**CERTIFICATE OF APPROPRIATENESS**

**Property:** 611 W 22<sup>nd</sup> Street/2201 Lawrence Street, Lots 31 through 48, Block 53, Houston Heights Subdivision. The property includes a historic 107,279 square foot, two and four-story brick industrial structure situated on an 117,900 square foot corner lot.

**Proposal:** Alteration - Sign

**SIGN DETAILS**

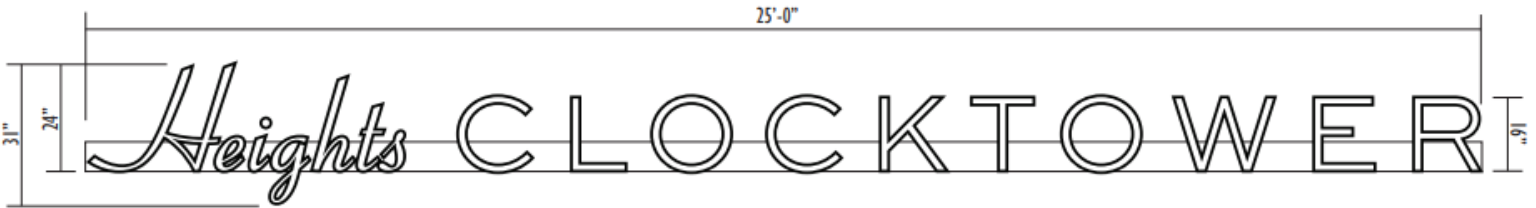
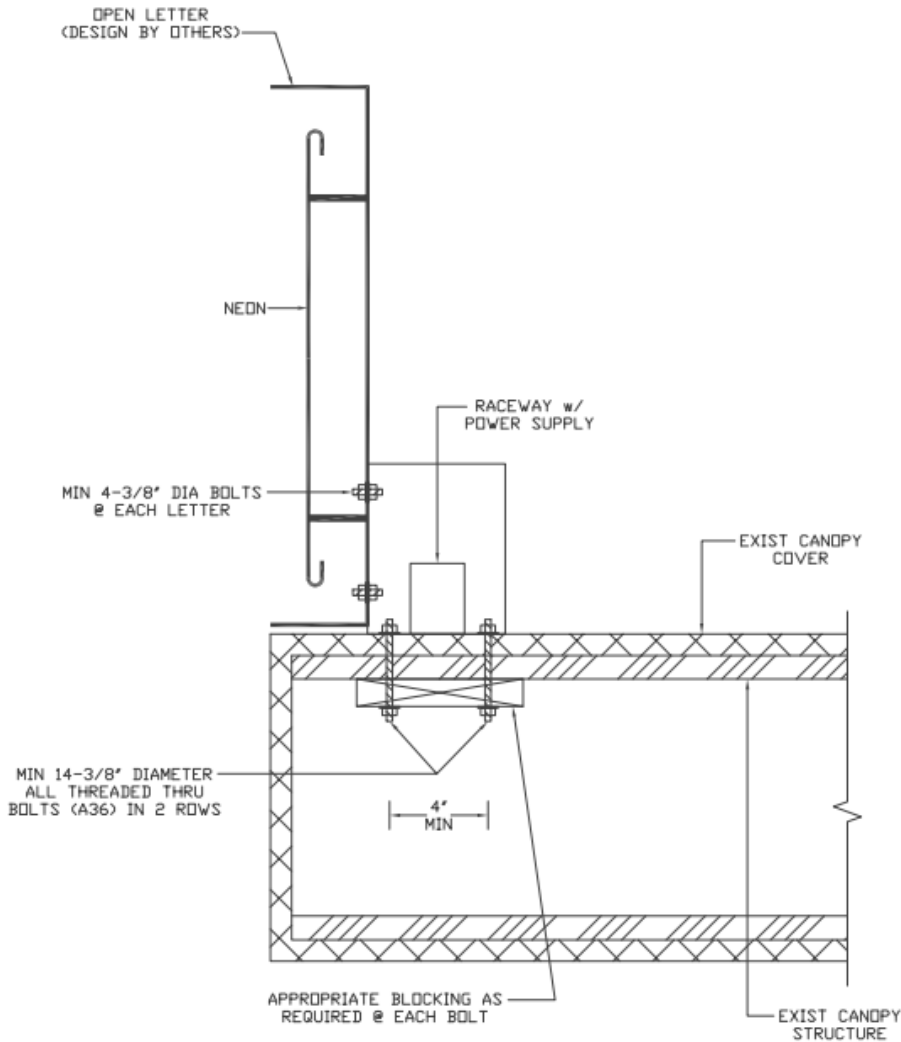
Install open faced channel letters of "Heights Clock Tower" signage with exposed single tube neon, 24"/16" TO 31" tall by 25' long. Sign will be about 50 sq ft.

- Welded Aluminum in matte black, open faced channel letters
- Meets Heights Design Guidelines for signage.
- **Information subject to change before final report**

**Recommendation:** Approval
